ADDENDUM No. 1

RFP No. 25-10

WESTGATE WATER MAIN PROJECT

CONCRETE CURB AND GUTTER

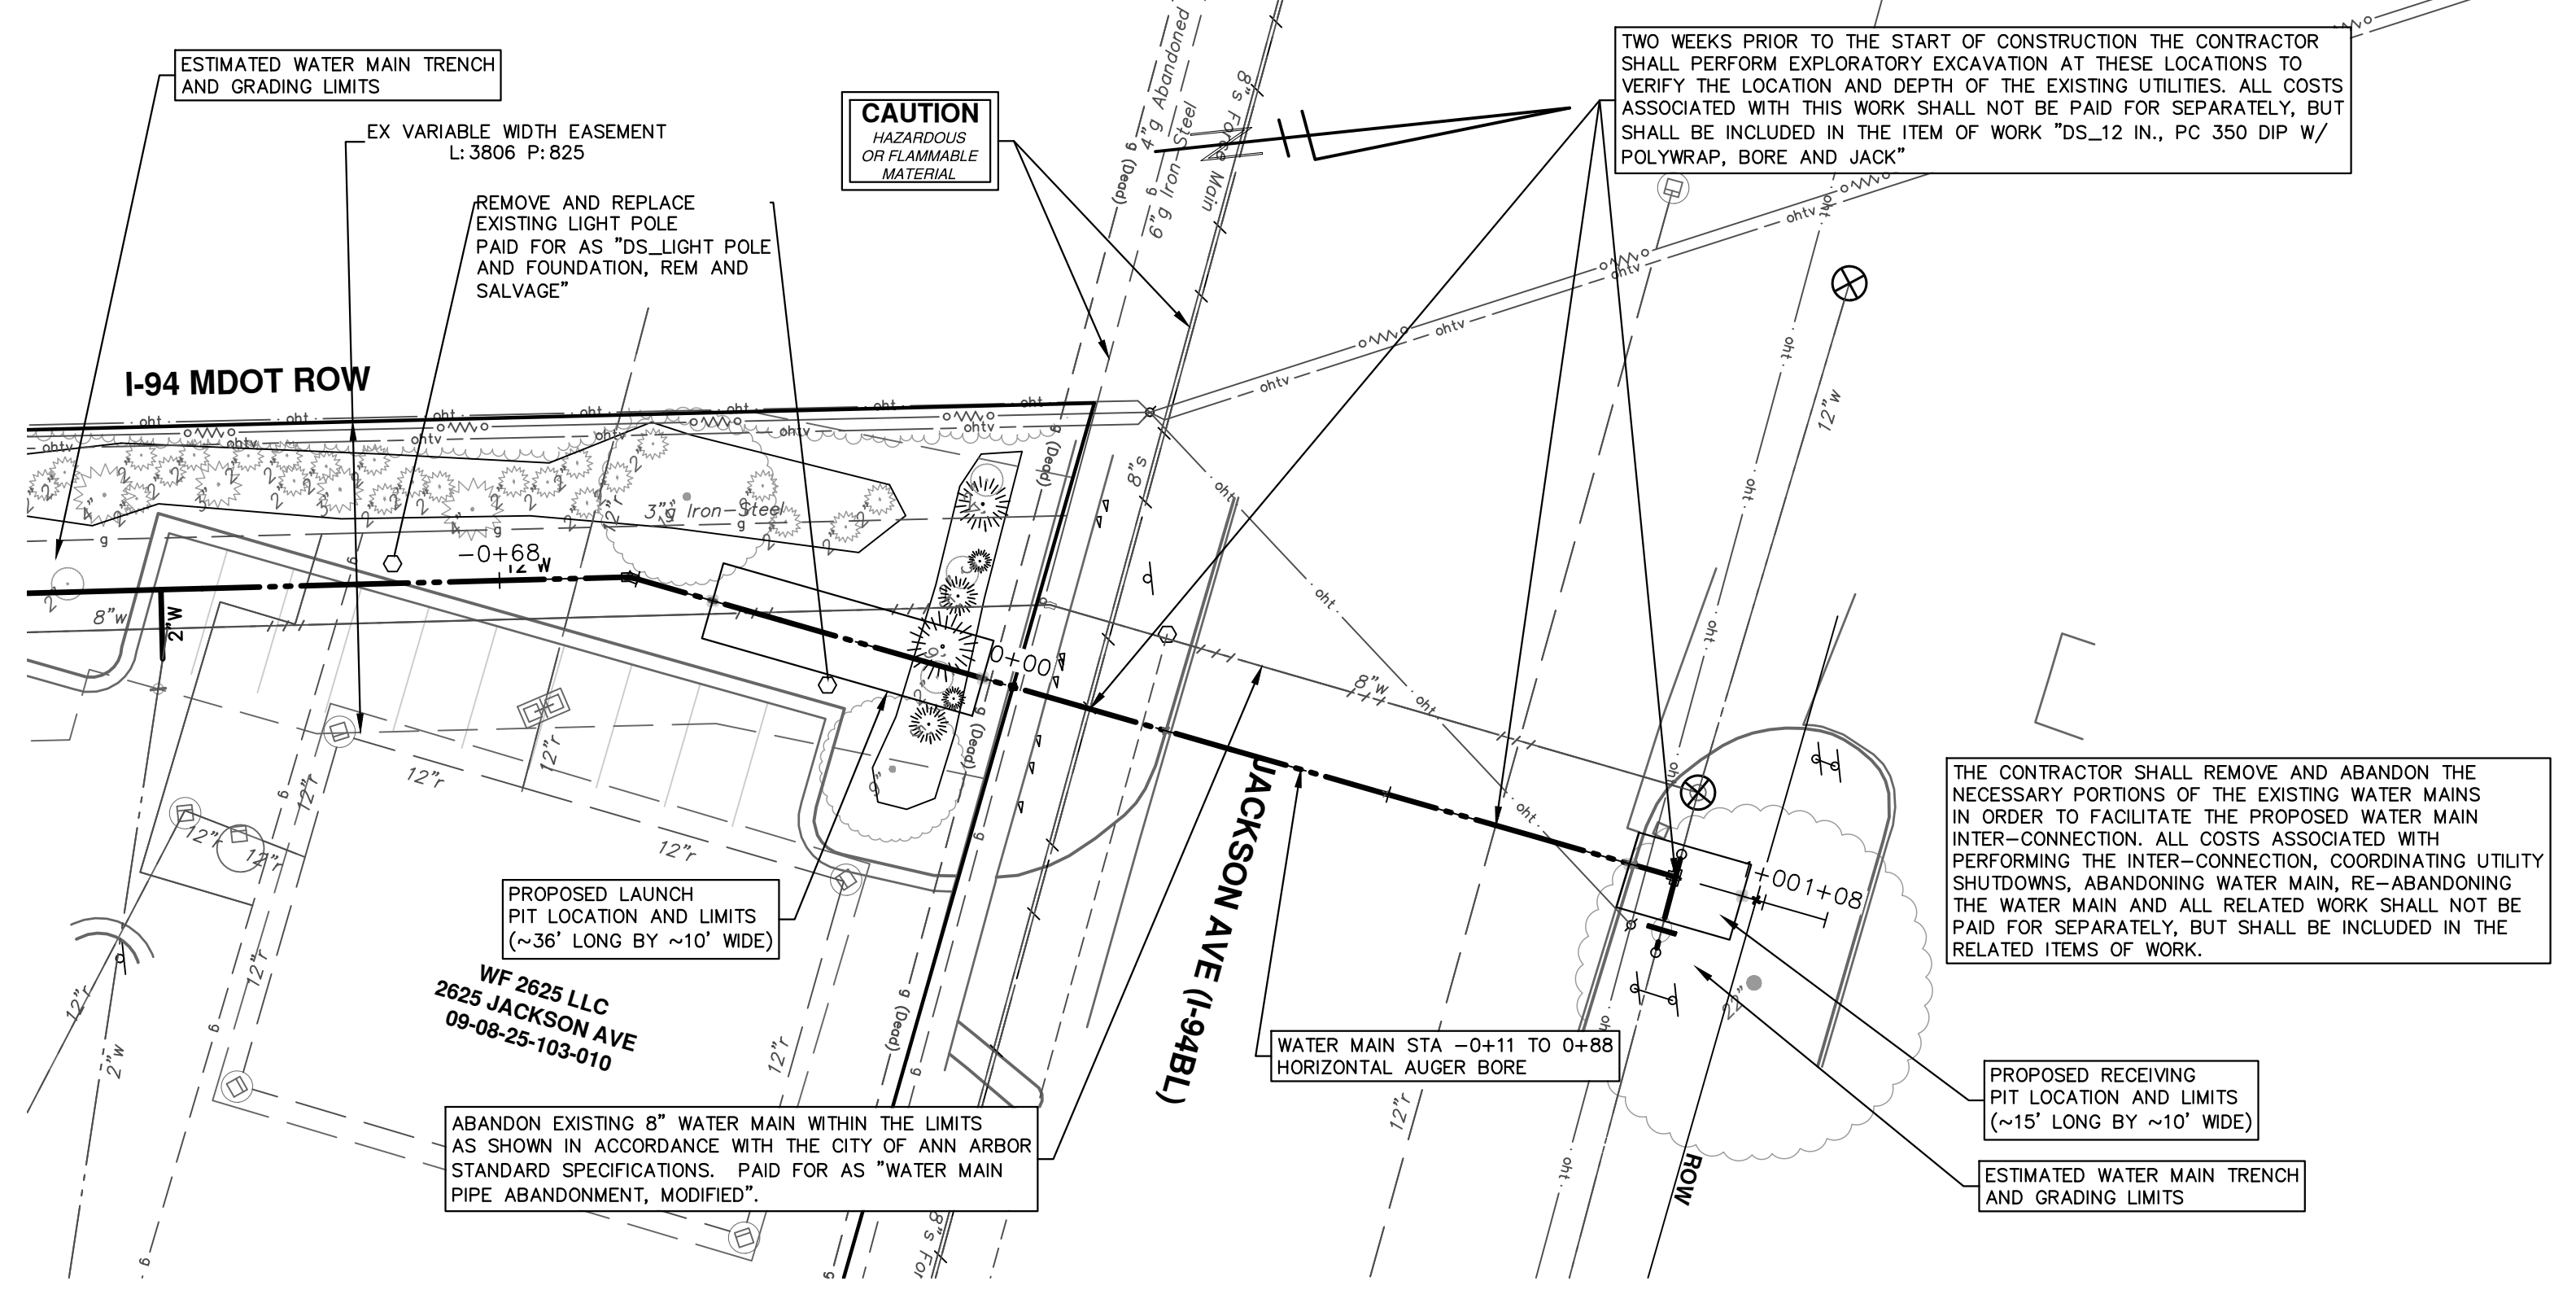
Question 13: Please provide necessary curb details for the proposed curbs for this project, including the required stone cross section.

Question 26: What is the detail for the approach/curb restoration in the MDOT right of way on sheet 34 of the plan set?

Answer 13: For curbs on City of Ann Arbor ROW or private property, please refer to City of Ann Arbor 2025 Standard Specifications, Article 12. For curb on MDOT Row, MDOT Curb Detail is located on Plan Sheet 27. Stone under curb will be 8 inches thick and it will be paid as "Aggregate Base Course, 21AA, CIP."

Answer 26: Please refer to MDOT Special Detail on Sheet, 27.

AA - JACKSON AVENUE JACK AND BORE UTILITY INSTALLATION

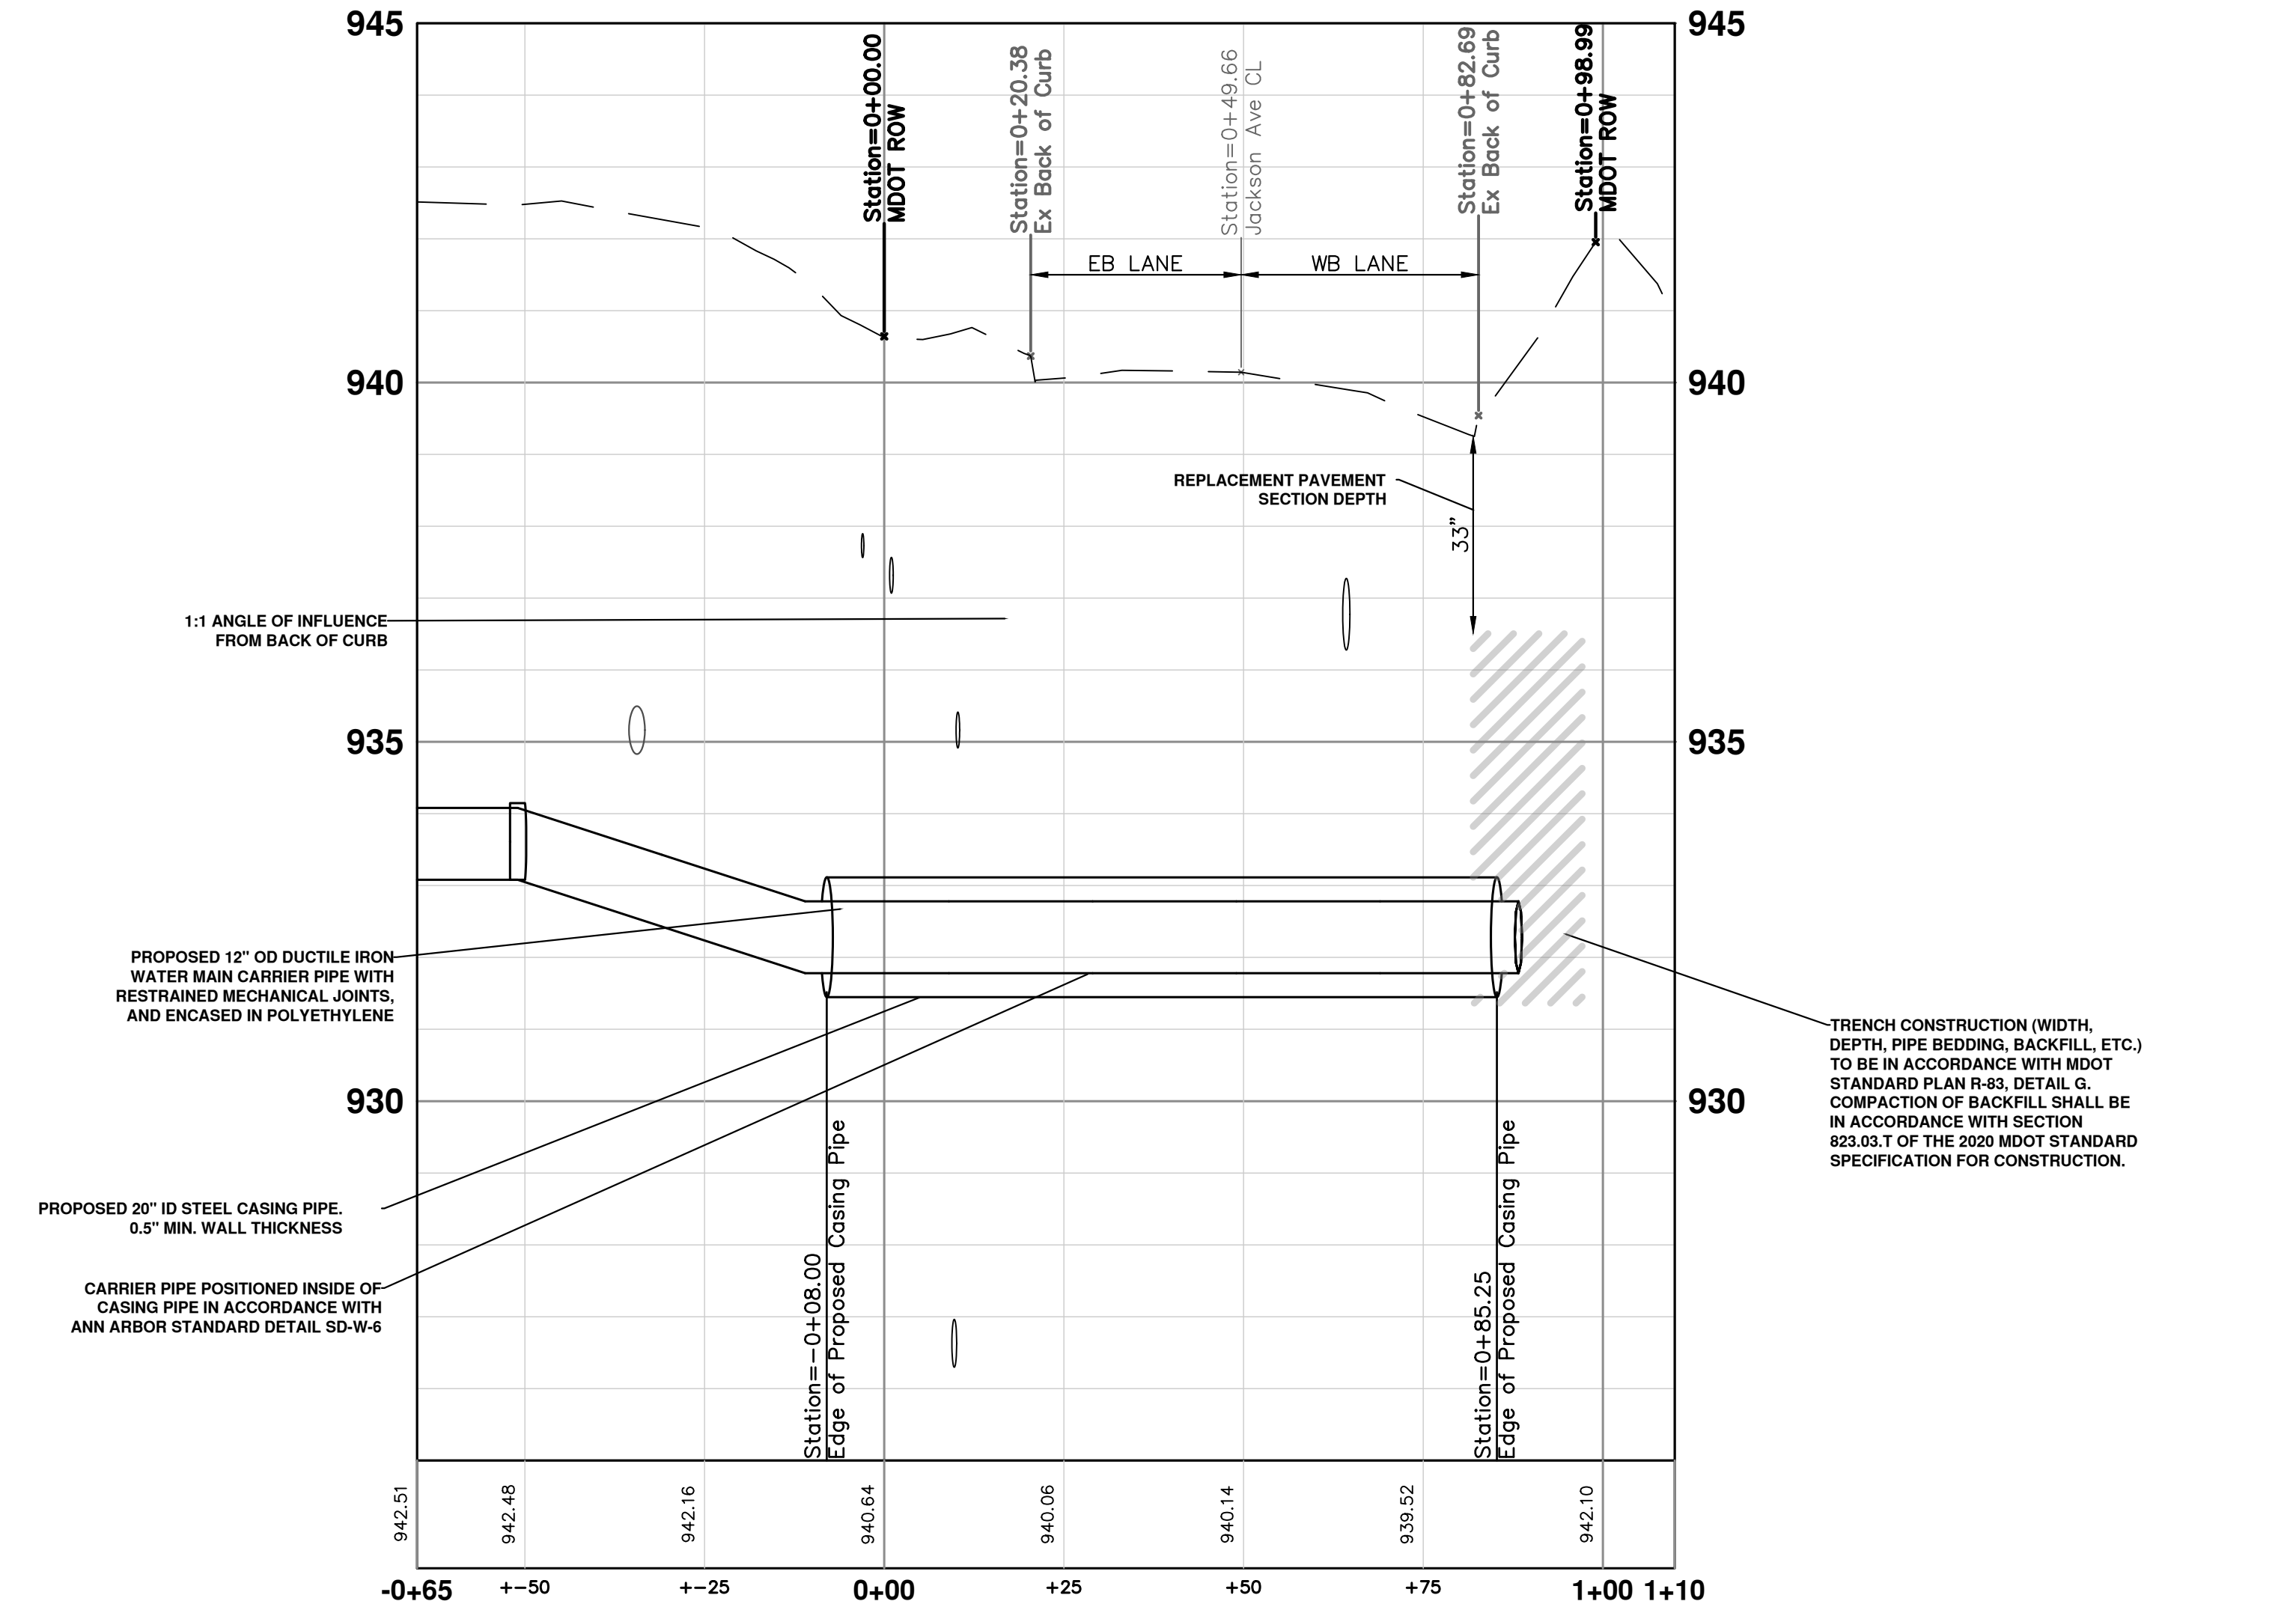
Question 34: There are concerns with the current alignment of the proposed water main at the proposed water main bore at Jackson Road.

- a. The proposed water bore pit is shown to be only 20' long. The standard bore pit length to auger and jack the pipe requires a 40' long pit. Water main pipe is 20' in length.
- b. There is an existing 3" steel gas service in the current proposed alignment for the bore pit. This gas service will have to be relocated and/or the alignment revised to perform the bore as you cannot push against the gas main or have suspended in the pit. Please advise how the 3" steel gas service will be addressed.
- c. The CL/CL of the existing 8" water main bend to the proposed 12" water main in casing is 2' apart. There is only inches of separation when the OD's of the existing pipe are figured in and that is not considering that there is also a thrust block at the bend. It is too close to the existing water main bend/thrust block to safely perform this work. Please advise how this should be handled.

Question 35: The proposed elevation of the water main at the bore is 7' deep. Assuming the existing water main is at 5.5' of vertical bends will need to be installed. Per the MOT plans a 12' lane needs to be maintained at all times (Sheet 14). This only leaves a maximum of 6' of working horizontal working space to install bends as required. Will portable concrete barrier wall be required for the proposed east side of Jackson Road tie in to create a safe excavation? Will PCB wall be paid for if needed?

Question 38: Will the bore and jack require grout between the carrier and casing pipe.

Question 40: Will the carrier pipe need to be fully restrained inside of the casing pipe?

Answer 34: The Plan set has been revised with requested bore pit dimensions and also a new alignment that takes into considerations concerns noted in the question. If utility conflicts are still a concern, additional exploratory excavation can be done to verify location of existing utilities before jack and bore.

Answer 35: Means and methods are up to the contractor. If a portable concrete barrier or trench box or other means is necessary for a safe excavation it will be incidental to the pay item "DS_12 In., PC 350 DIP w/polywrap, Bore and Jack". Please note that alignment has been shifted to allow for a larger bore pit.

Answer 38: Please refer to Sheet 27, Typical Type Casing Standard Detail or City of Ann Arbor Standard Specifications, Article 12, SD-W-6 which includes information on the required spacers inside of the casing pipe. No grouting is required.

Answer 40: Please refer to Sheet 27, Typical Type Casing Standard Detail or City of Ann Arbor Standard Specifications, Article 12, SD-W-6 which includes information on the required spacers inside of the casing pipe. Due to the design configuration especially at the tie in location, restrained joints are necessary from the bore pit to the receiving pit. This change has been reflected on Sheet 26.
